Central Coast Regional Water Quality Control Board
Prosecution Team Evidence
in the matter of
Cease and Desist Order R3-2016-0015
Exhibit 6

Wastewater Analysis

Centrally Grown
Cambria, CA

October 2012

CENTRALLY GROWN
WASTEWATER SITE PLAN
FIGURE 1

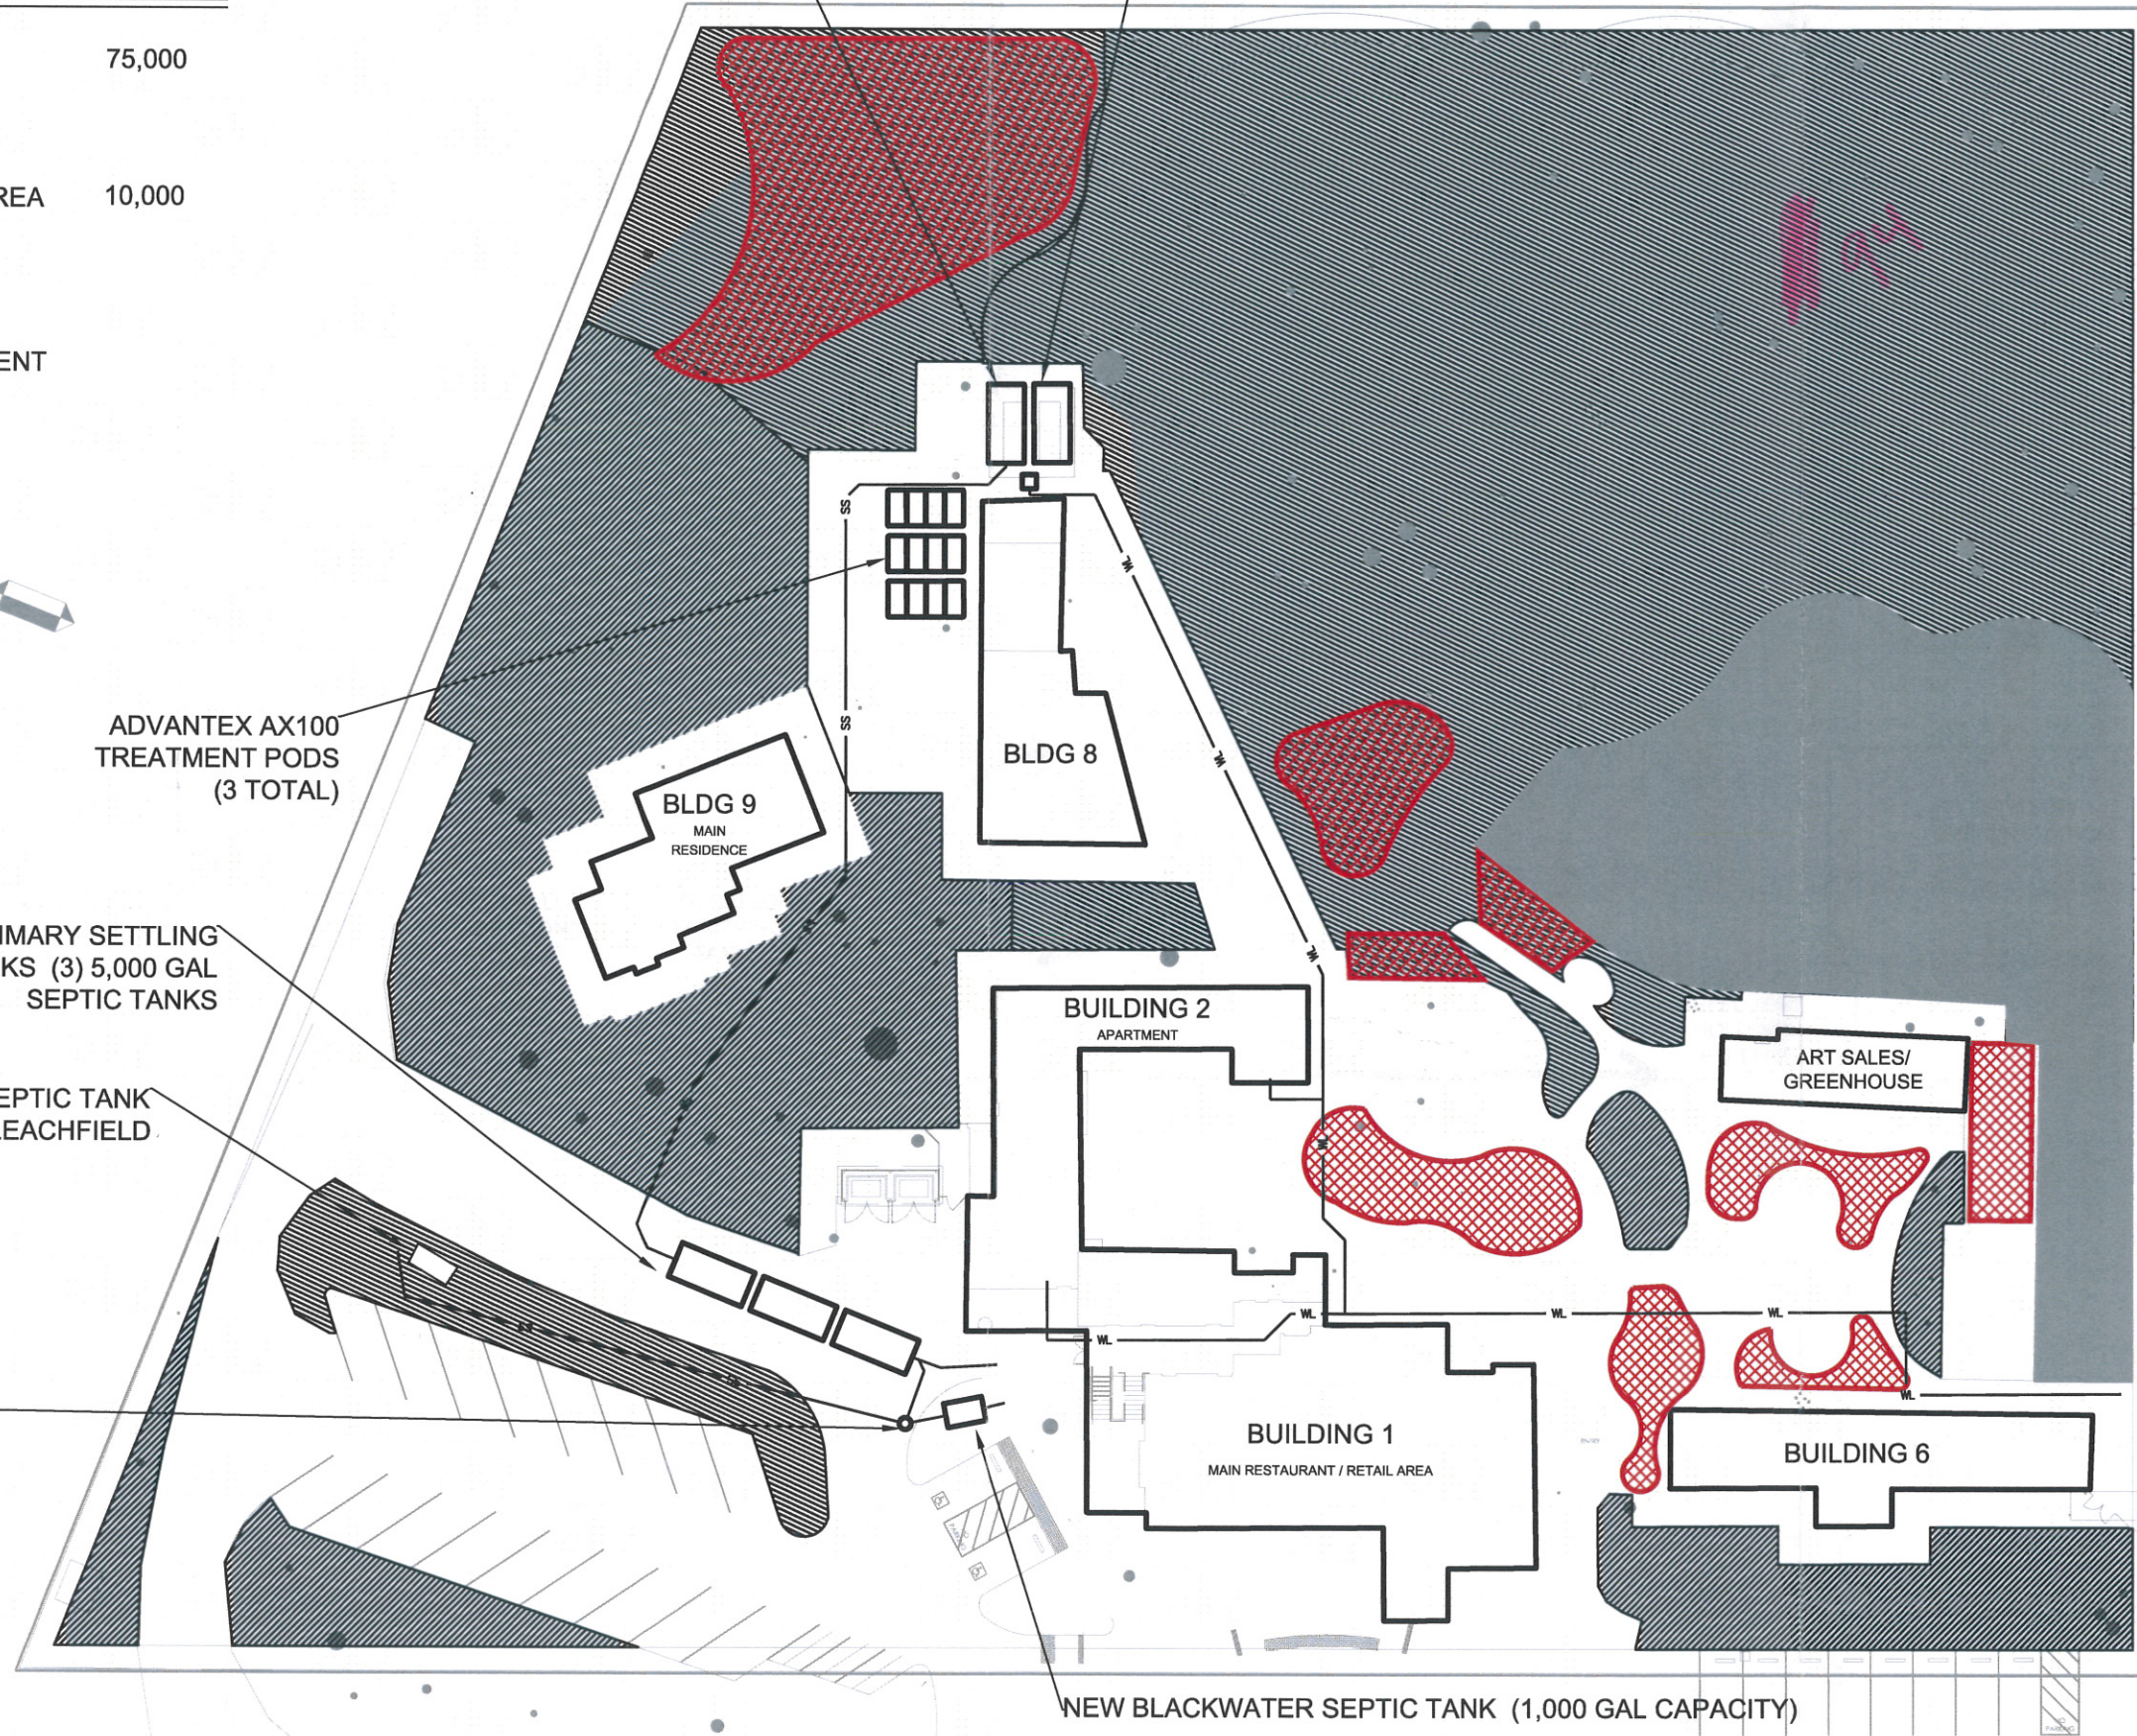
[water supply with ind well?]
